Ward: Tottington Item 04

Location: Land at 12 Holthouse Road, Tottington, Bury, BL8 3JP

Proposal: Application for reserved matters (access, appearance, landscaping, layout and scale)

Application Ref: 71700/Reserved matters **Target Date**: 06/05/2025

Tmed Daily Summer Solstice

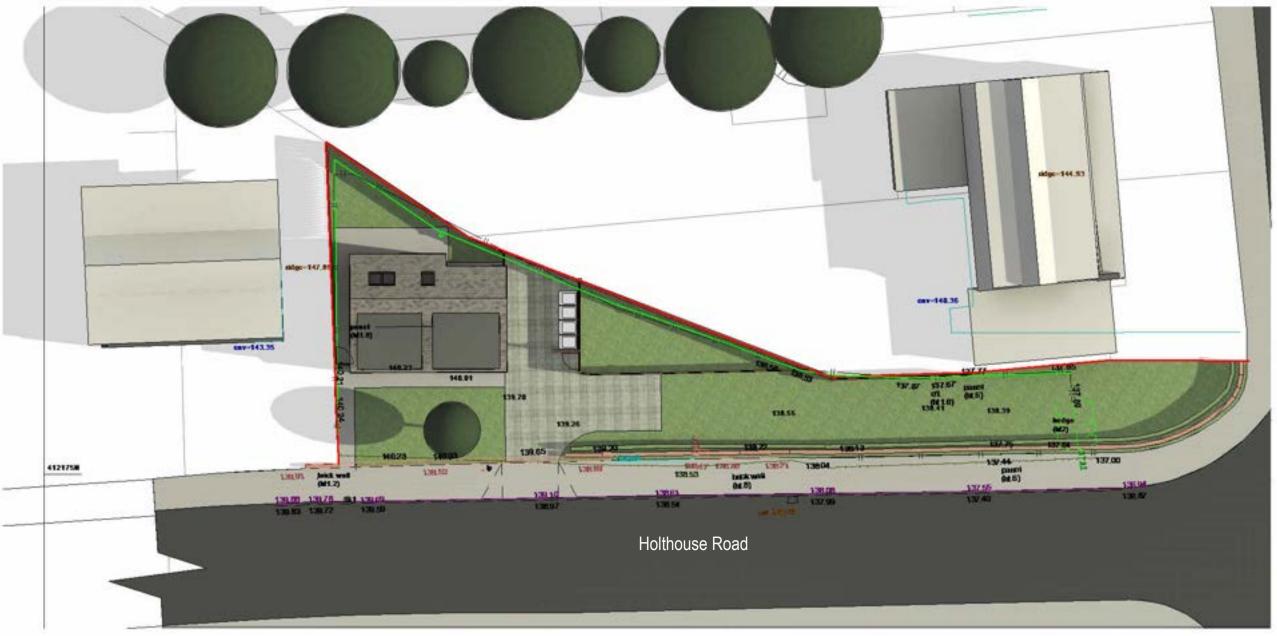
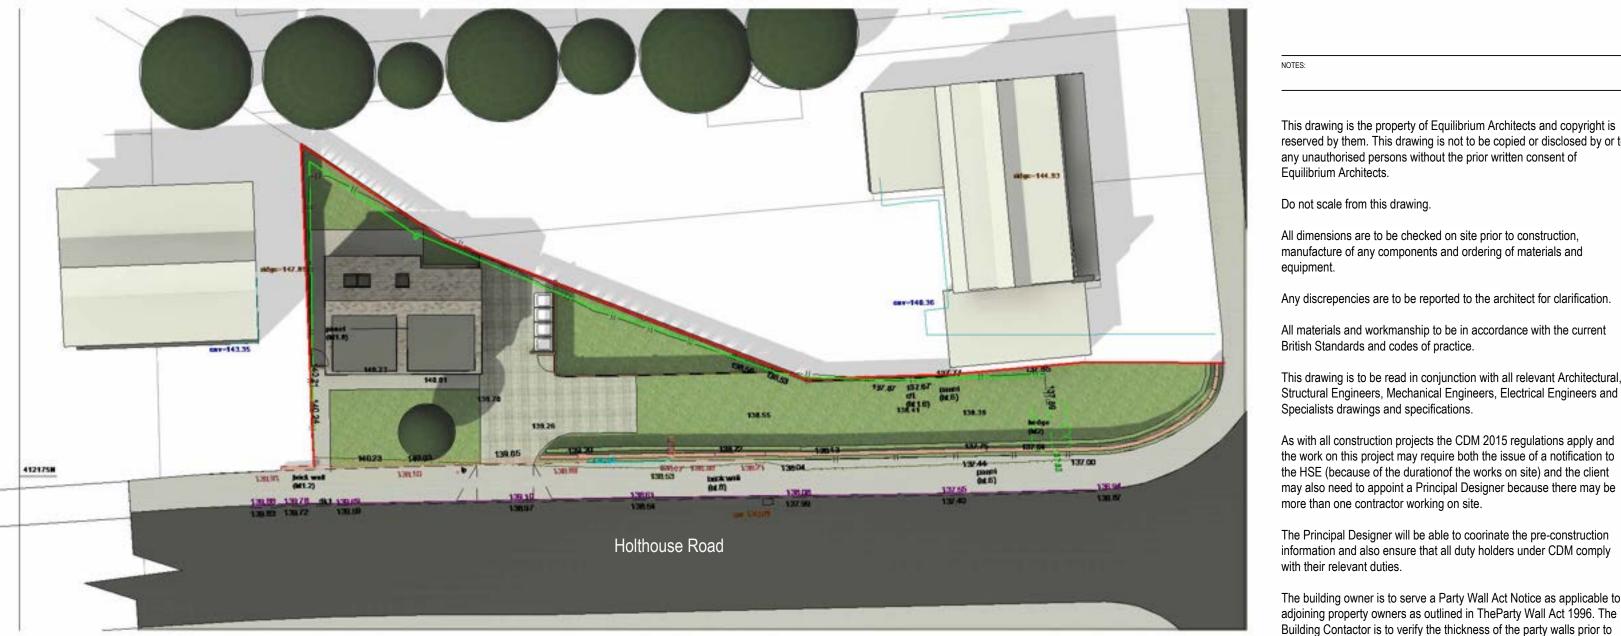
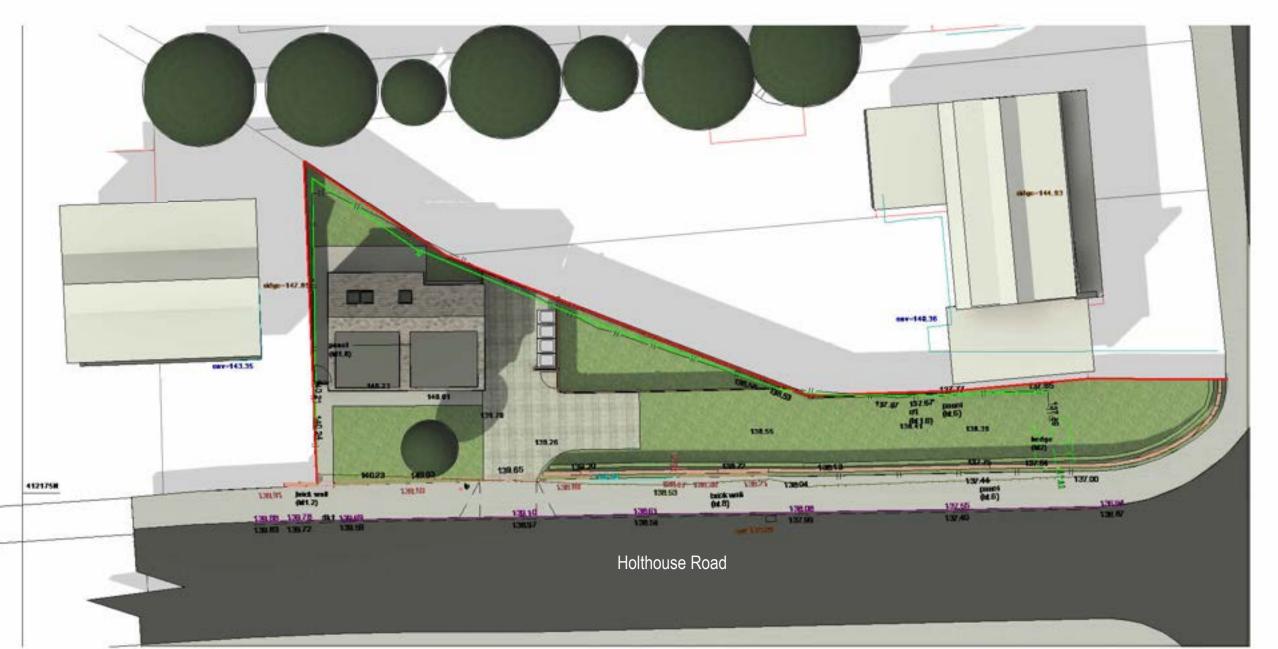
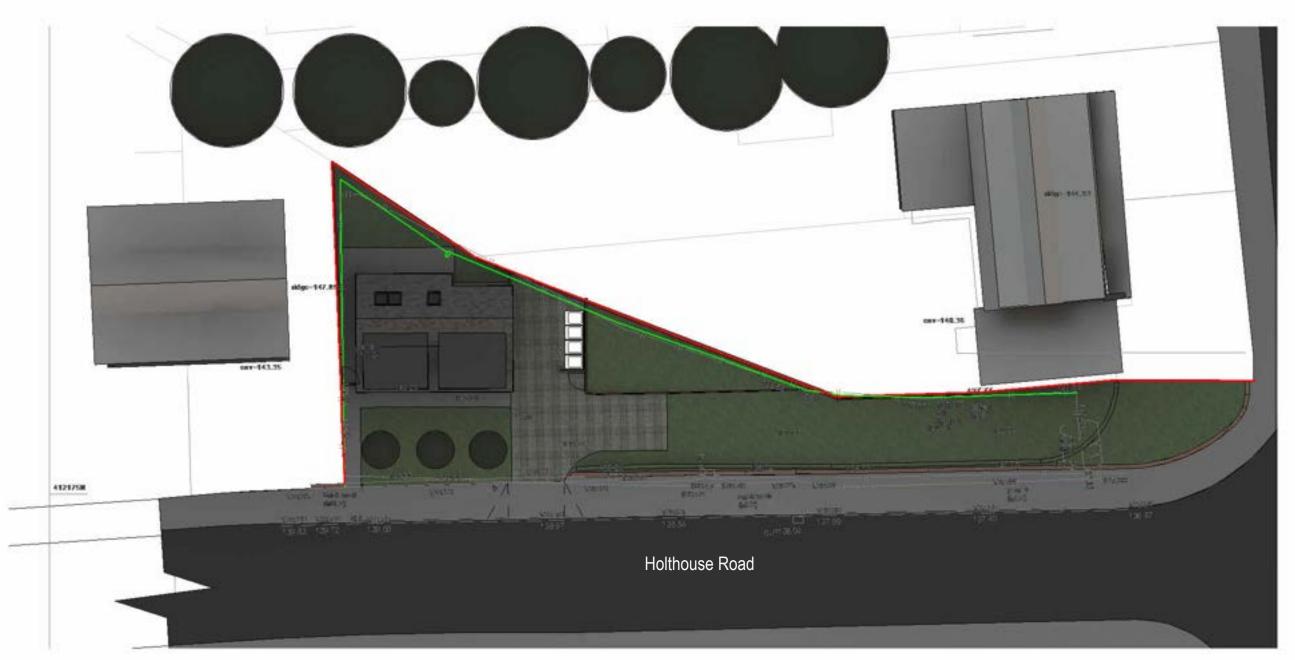
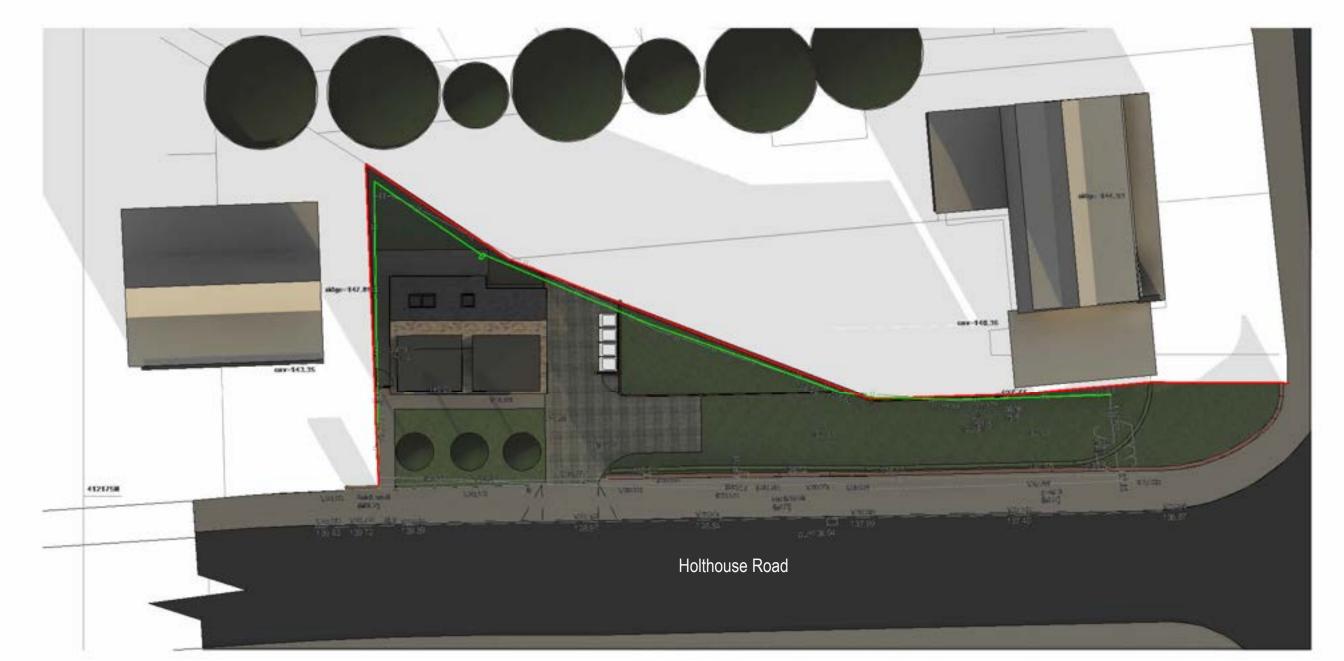
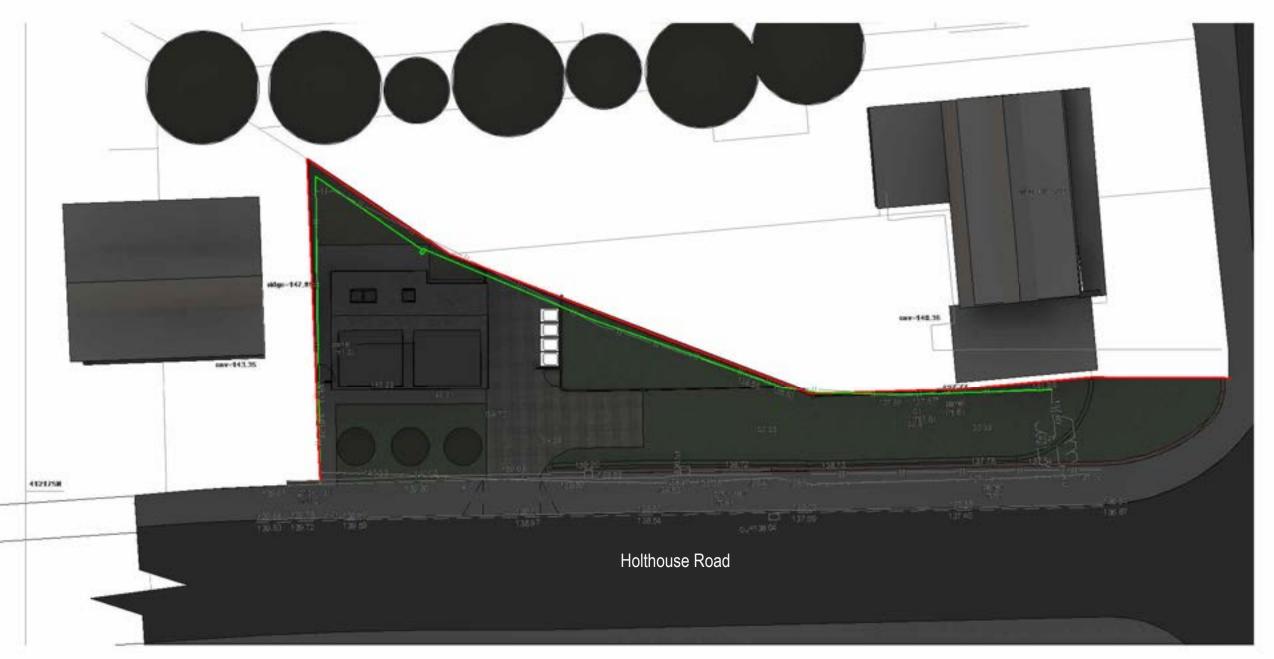
In the Summer months, there would be some overshadowing of the garden to No 10 later in the afternoon and evening but this would only affect a strip of land along the boundary fenceline and the end of their garden, which is generally less used as amenity space. The majority of No 10's garden area would be unaffected by the siting of the dwelling.

In the Winter months, No 10 itself overshadows their garden at the early times of the day, and whilst the development would cause overshadowing during the day, by later afternoon and evening, dusk would settle and light would fade. Gardens also tend to be used less in the Winter months.
